INITIAL FIRE SAFETY INSPECTION REPORT

Confidence Texwear Ltd.

Factory ID: 24120

Date: 8-Feb-2021

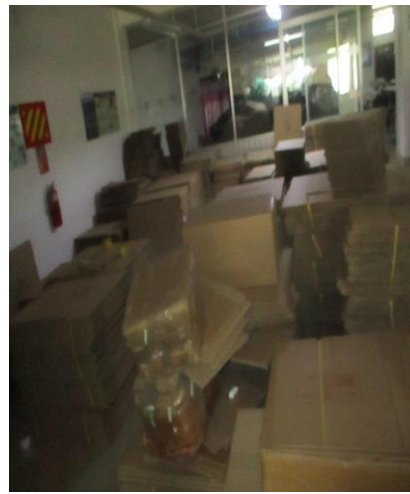
F-2	Fire Rated Construction	Unsealed penetrations and openings are located in the exit stair enclosures. Location: 1st Floor, Stair-1	Seal all penetrations and openings in exit stair enclosure walls to maintain the fire separations.	3 Months
